# **MULBARTON PARISH COUNCIL**

## **Hornsea Project Three**

### **Deadline 6**

Figure 4.15: Constraints mapping of onshore HVDC converter/HVAC substation search area.

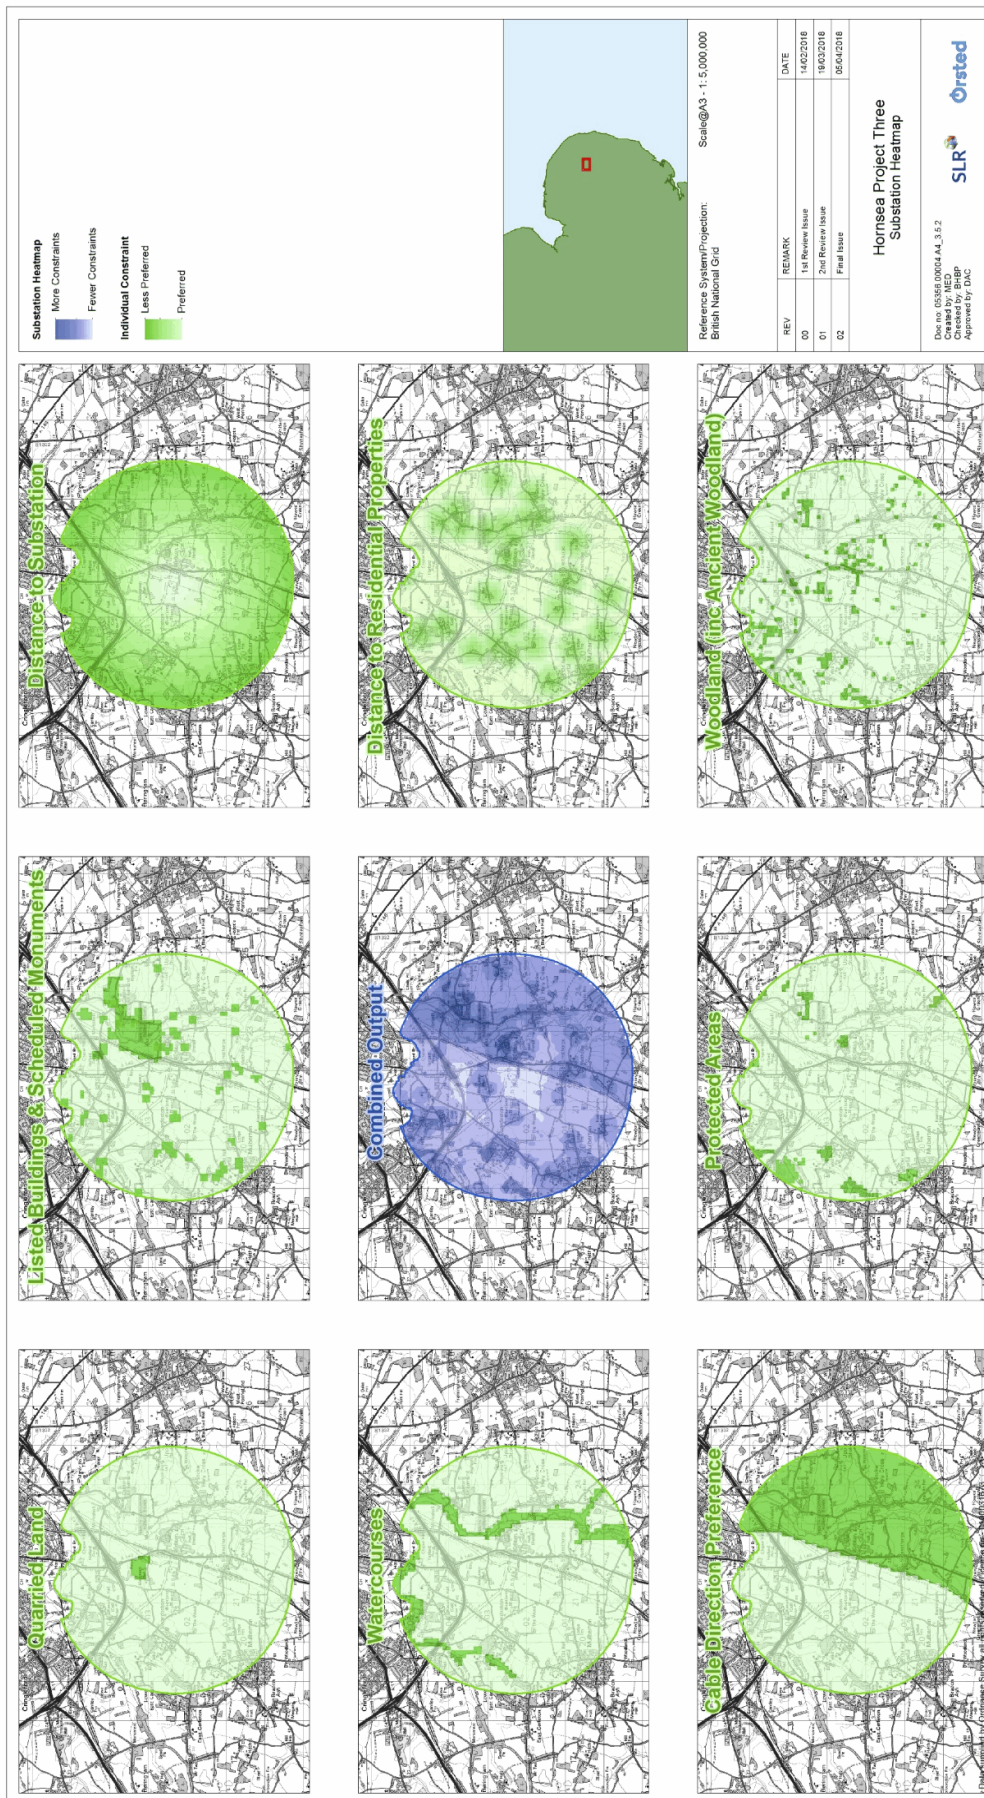
The site selection process is illustrated on page 31 of the relevant document<sup>1</sup>, as shown in Attachment 1. This procedure identified the general area of Option A as being subject to the least number of constraints, but does not appear to have considered the local planning policies applicable to Option B, as shown on the policy map<sup>2</sup> in Attachment 2.

<sup>4</sup> See for example, para 4.10.7.16 of the Consideration of Alternatives document, which states: 'Due to the early stage of technical investigation at the point of the Phase 1.B consultation events, the specific sites presented in Figure 4.15 were not shown at the consultation events as work was ongoing to determine whether each was considered to be technically feasible. However, the heat mapping exercise was presented to demonstrate the process that Hornsea Three was using to try to identify potential sites.'

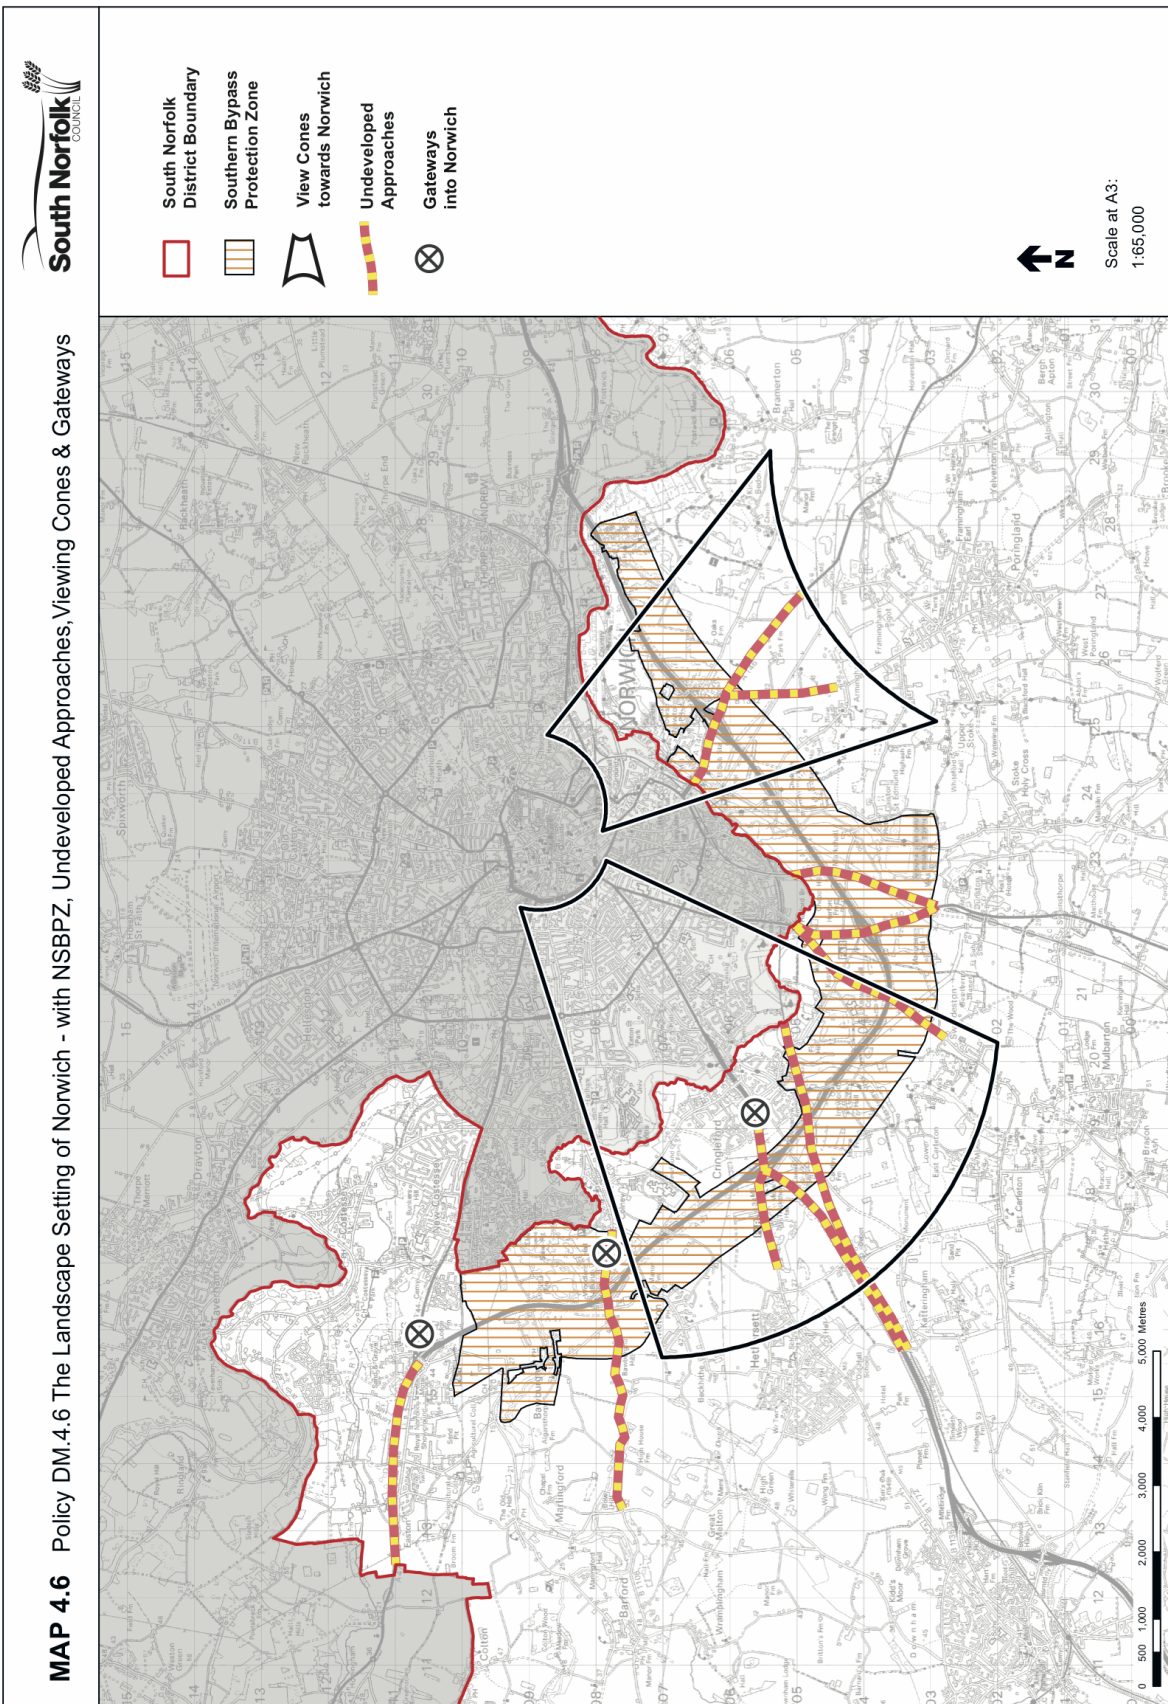
In particular, Option B would seem to be in conflict with three local policy criteria:

- (a) The Norwich Southern Bypass Landscape Protection Zone (NSBLPZ);
- (b) View Cones towards Norwich (the viewing cone from the south-west);
- (c) Undeveloped Approaches (the B1113, to the north of Swardeston).

Onshore converter substation – Options A and B

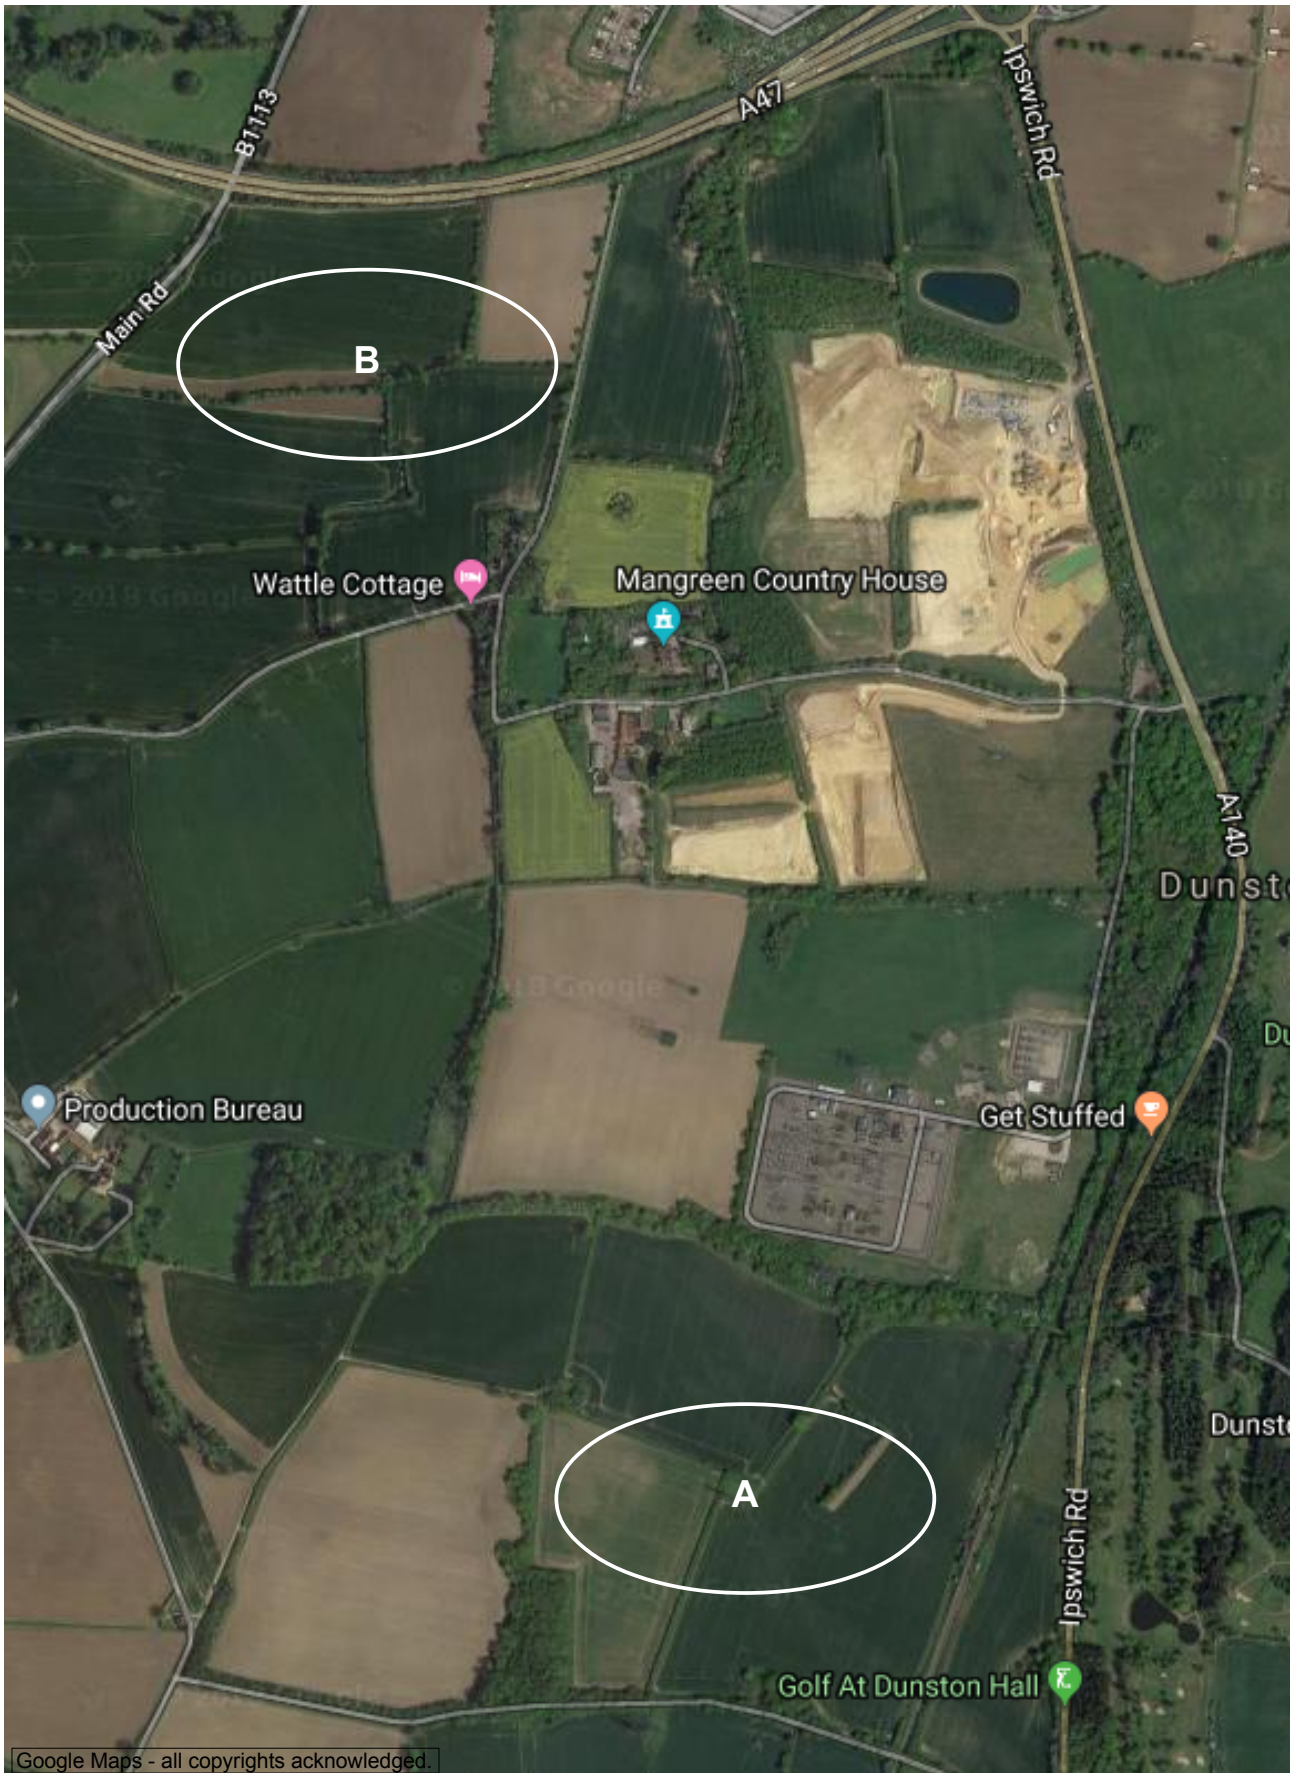
The positions of Options A and B, and also of Mangreen quarry, are shown on an aerial view in Attachment 3. The northern section of Mangreen quarry was correctly identified in the selection process as 'quarried land', even though it was no longer in use for extraction when the evaluation was carried out. The southern section is not identified at all. Although that section is currently still being worked, there are good reasons to expect that extraction will cease before the currently authorised date of 31st December 2021. The two adjoining sites previously identified for mineral extraction have recently been withdrawn.

These considerations suggest that Option A would not be significantly constrained in terms of either temporary or permanent space requirements, maximum acceptable height of installed equipment, or vehicle access to and from the road network.
